GHD cross-sections v2 for Steering Committee meeting on 24th Oct

Cross Section & Case Study Review Memorandum

To	Shelley Bennett (CoPP), Alex Robinson (CoM)		
Copy to	Theodora Hogan (Melbourne Water), Todd Berry (DELWP)		
From	David Howard	Tel	+61 3 8687 8789
Subject	Fishermans Bend Streetscape Case Study Review	Job no.	3136555

Fishermans Bend Drainage Strategy – Case Study Review

GREEN STREET
ALTERNATE
CONFIGURATION
SKO1.
NTS GHDW.
5.10.2018.

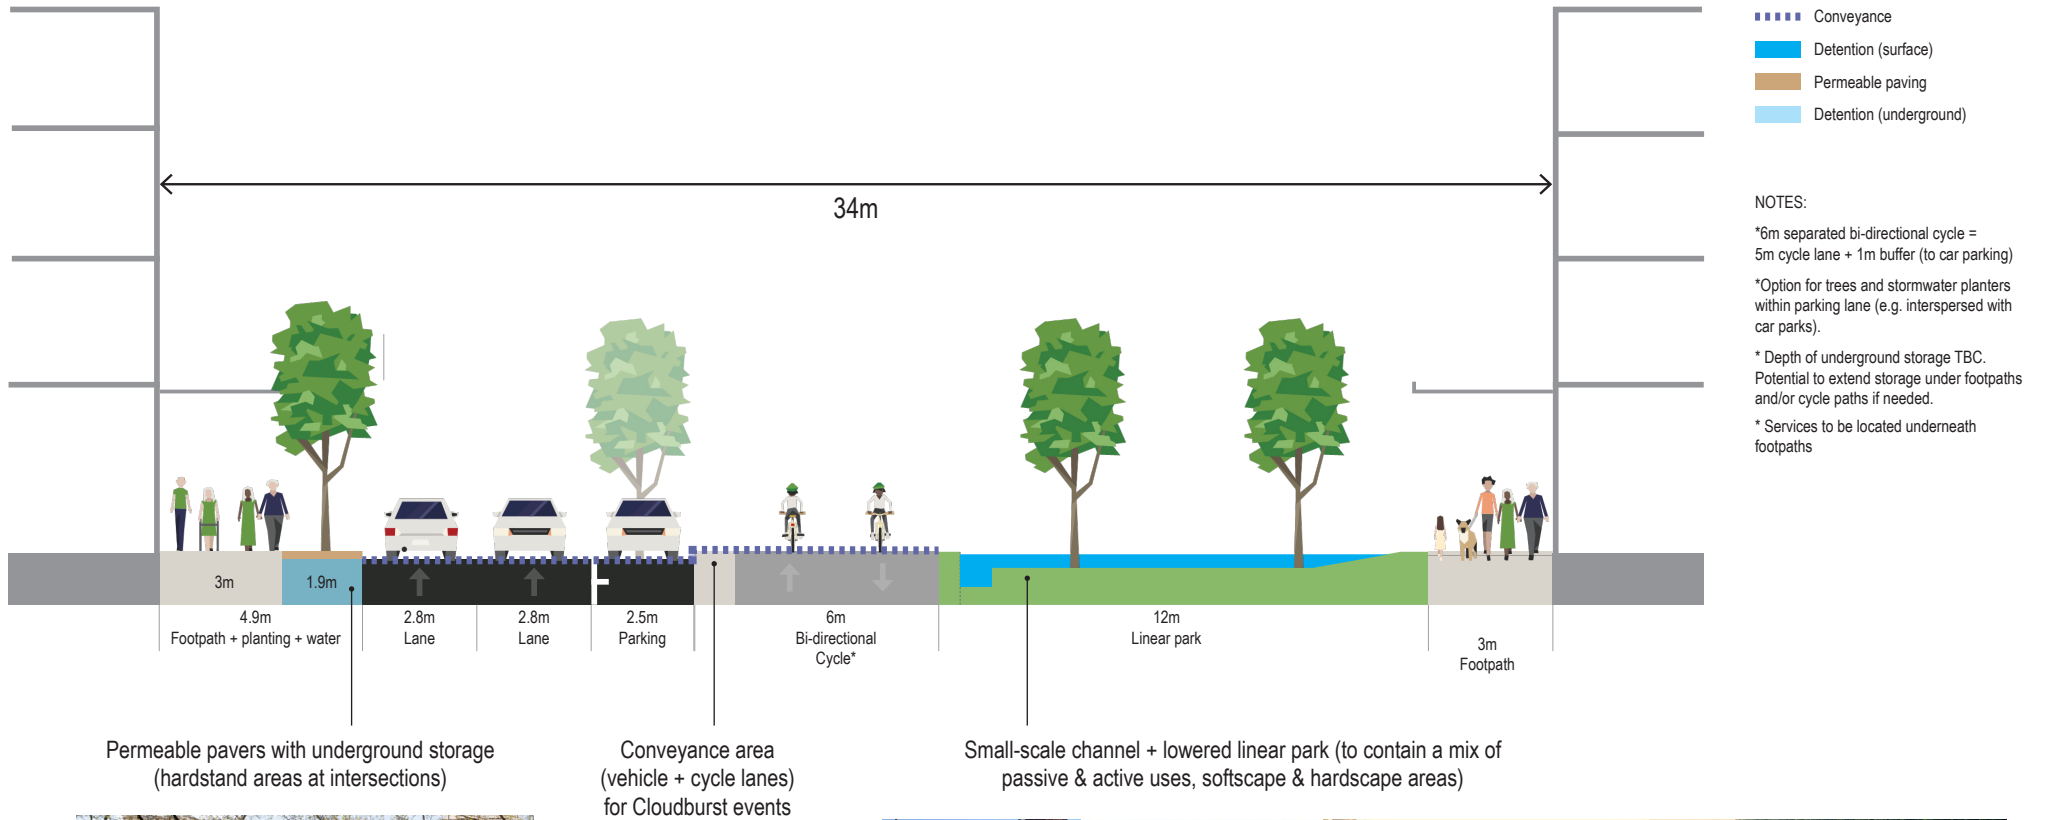
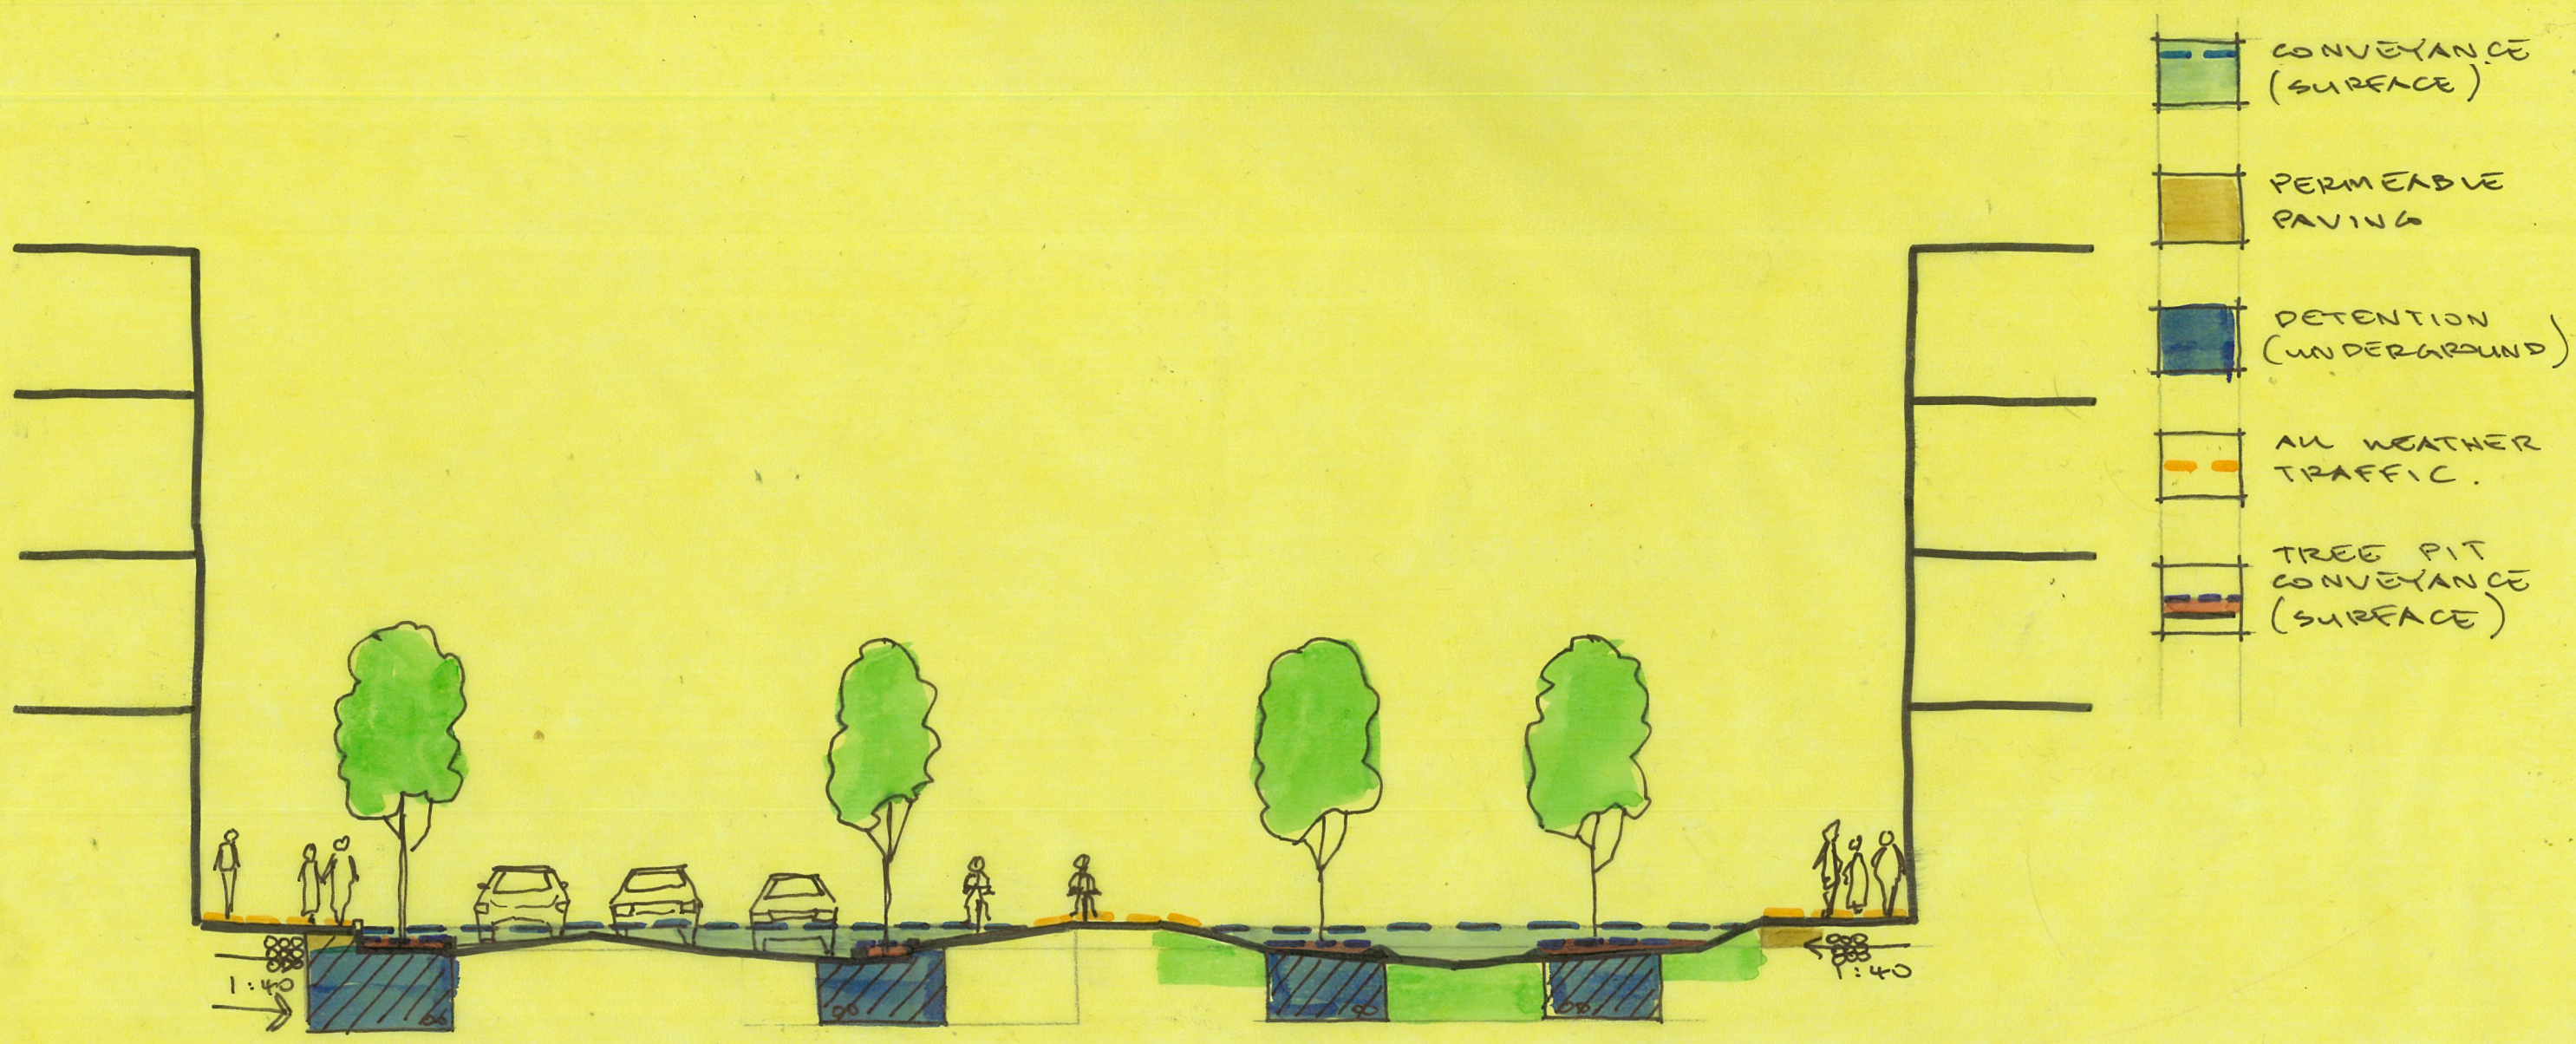
The existing sections do not provide adequate vertical detail to critique streetscape cross fall, grades and drop-offs. Refer to the attached Graham St cross section for a before and after comparison of how the streetscape cross fall, grades & drop offs can be improved. Further collaborative work is required here.

Based on the review of the Graham St cross as an example, the depth of detention areas within the streetscape is likely to be a minimum 1.5 m below the ground level (current sections show a 1.0-1.35 m deep approach). With this as a starting point the JL Murphy Reserve would need to (not consider broadening the catchment area, which would likely deepen the detention requirement or part thereof). Any future detention requirements should consider future smart tank consideration, retention, and reuse on open space (i.e. not all the water draining to JL Murphy needs to be pumped to a receiving waterway/Port Phillip Bay).

Refer to the attached Graham St cross section for a before and after comparison of how the streetscape drainage functionality, vertical depth of detention systems, streetscape cross-falls/grades/drop-offs, and conflict with existing/future provision of services can be improved.

A detention area exceeding the 3.2 sq m target can be provided (based on Ramboll green street detention interpretation).

A conveyance area equivalent to 10 sq m can be provided (in accordance with GHD modelled area), and is based on:

- Tree pits/raingardens providing an average 400 mm of conveyance (1.66 sq m);
- Road and parking bay providing an average 350 mm of conveyance (2.84 sq m);
- Cycle path providing an average 325 mm of conveyance (1.95 sq m); and
- Linear park providing an average 350 mm of conveyance (3.60 sq m).

The maximum allowable depth of flooding was assumed to be 400 mm at any one point in the streetscape.

2.9M
PERMEABLE
PAVEMENT.
& STRUCTURAL
SOIL W/
STORAGE.

GRAHAM ST
SK01-A
NTS.
GHDW
8.10.2018.

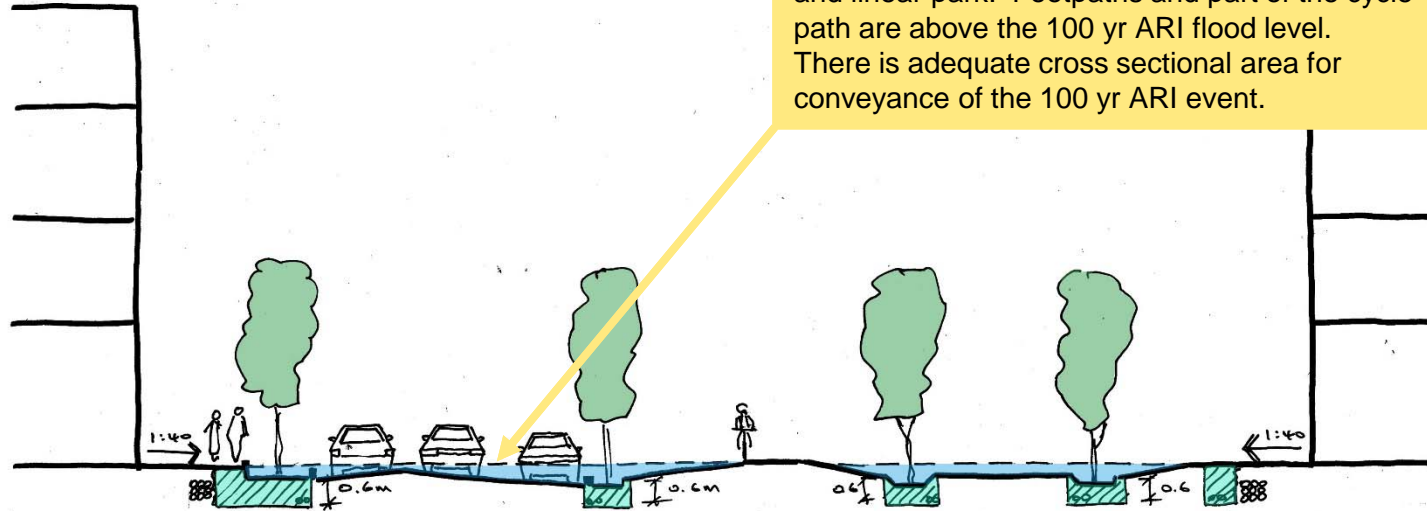
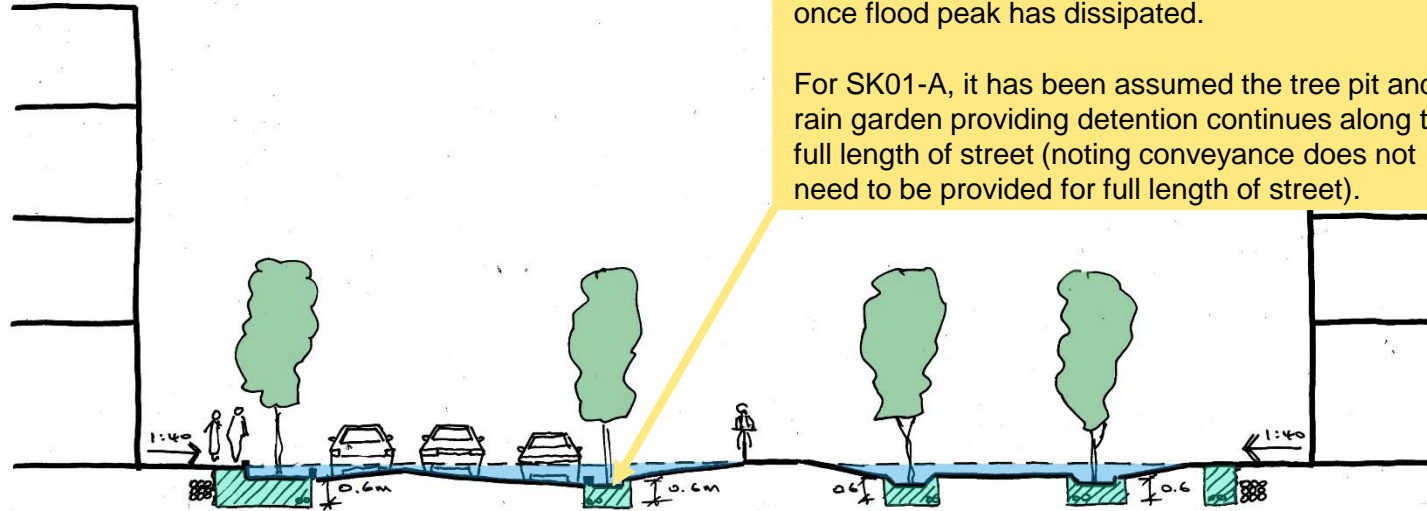
Tree pits provide conveyance and detention (assuming gravel backfill below root ball in lined storage). Tree pit detention free drains via ag lines once flood peak has dissipated.

GREEN STREET (ALTERNATE GENERAL ARRANGEMENT)
 GRAHAM ST - GREEN ST
 (34 M W LINEAR PARK.)

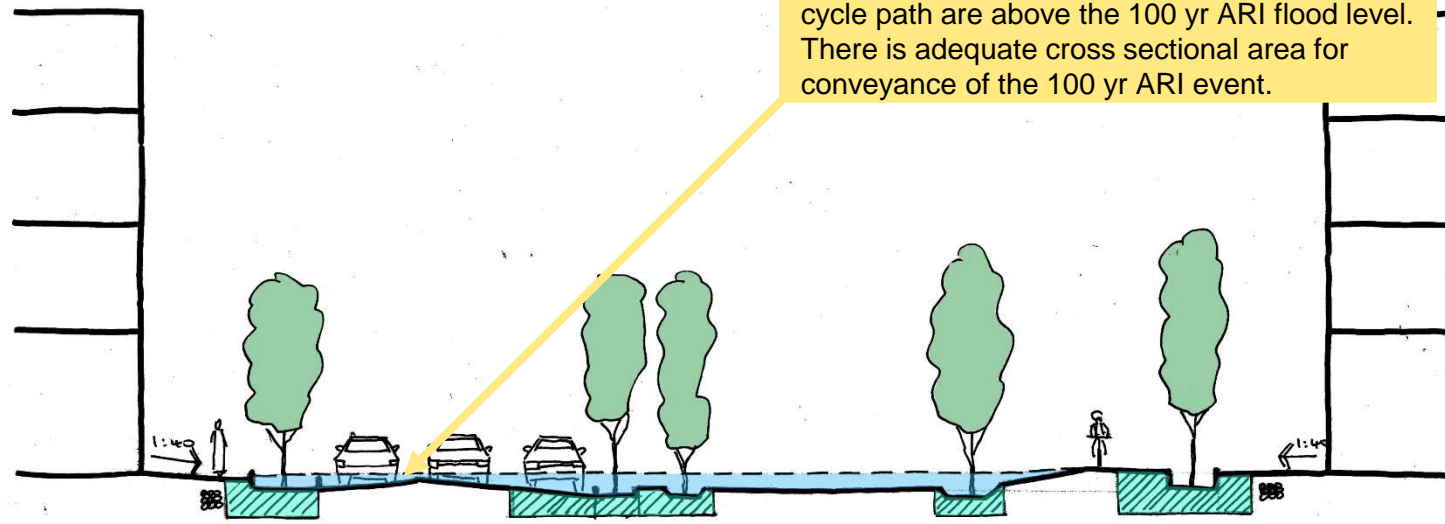
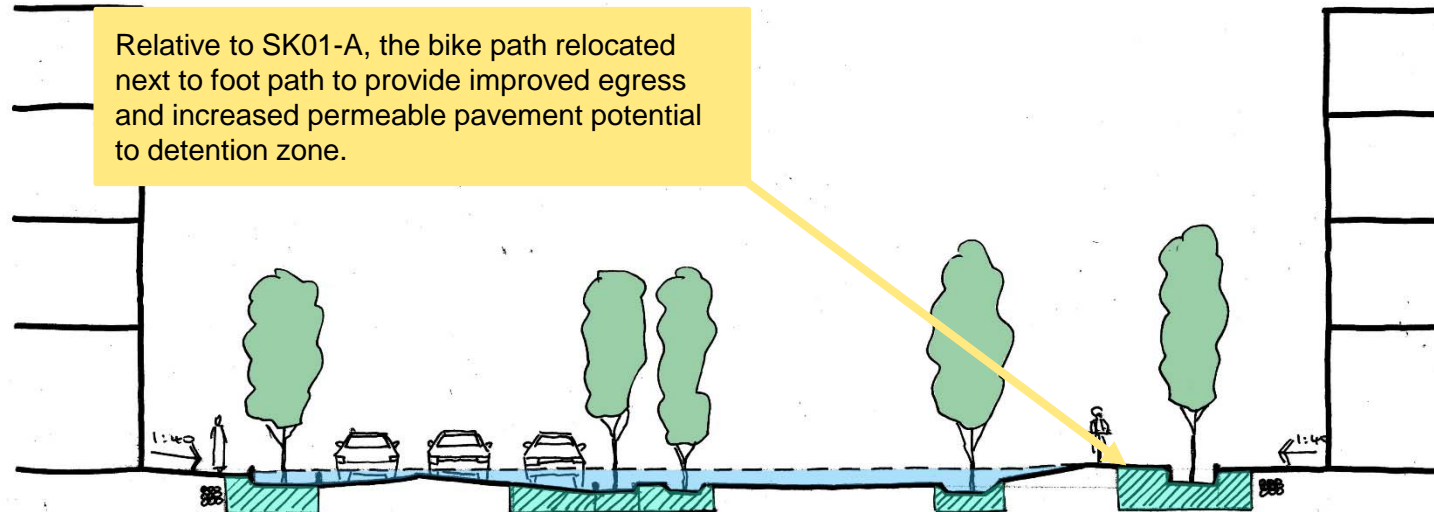
The 100 yr ARI flood event is confined to road and linear park. Footpaths and part of the cycle path are above the 100 yr ARI flood level. There is adequate cross sectional area for conveyance of the 100 yr ARI event.

Relative to SK01-A, the bike path relocated next to foot path to provide improved egress and increased permeable pavement potential to detention zone.

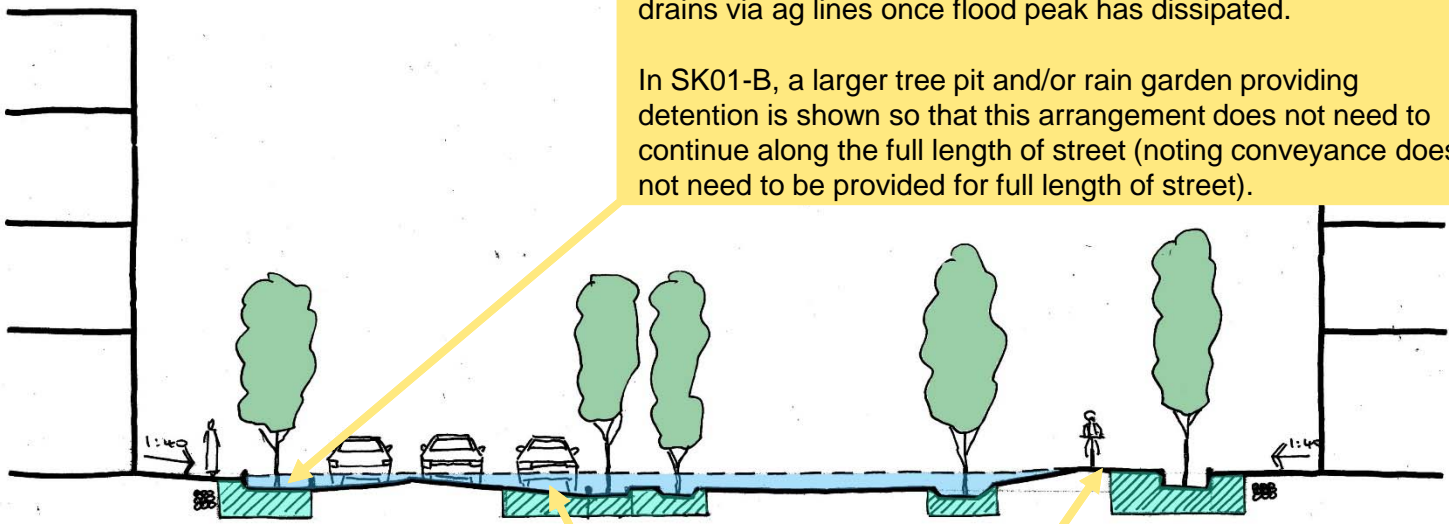
In SK01-B, a larger tree pit and/or rain garden providing detention is shown so that this arrangement does not need to continue along the full length of street (noting conveyance does not need to be provided for full length of street).

CLODBURST BOULEVARD
 PLUMMER ST. CIVIC (36m)
 FENNEL ST.

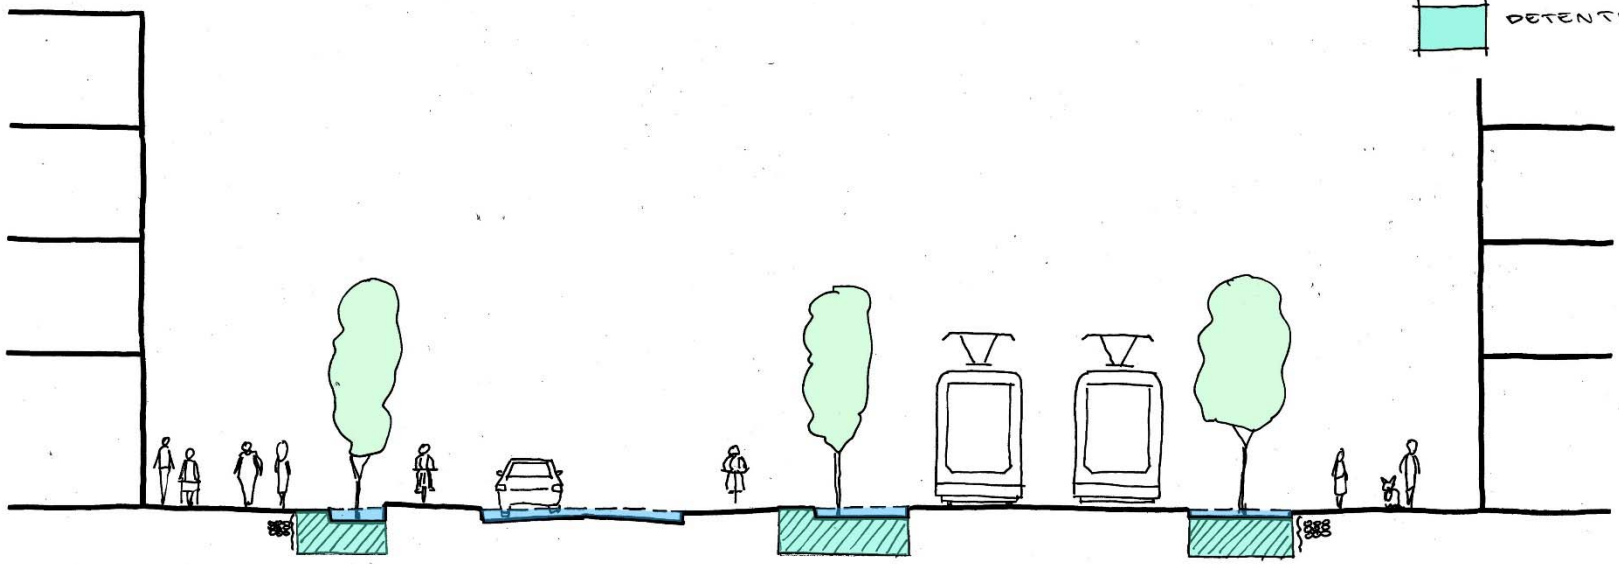
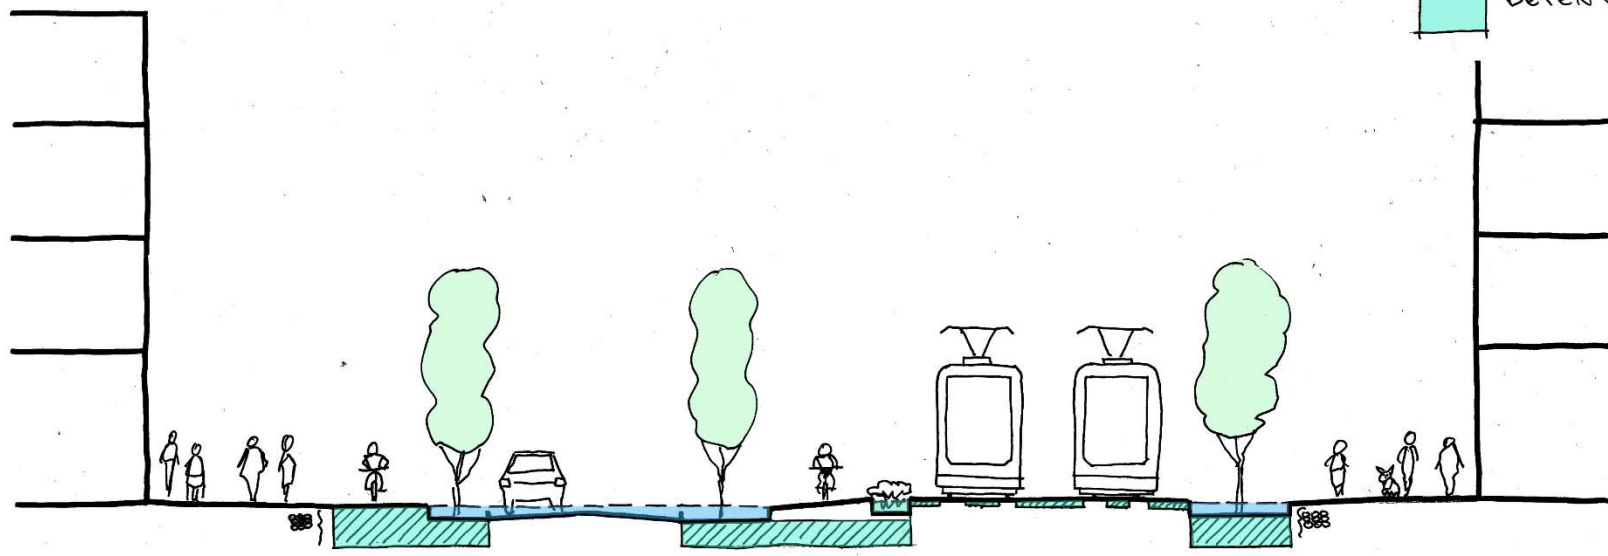
ADDITIONAL STORAGE OPTION.
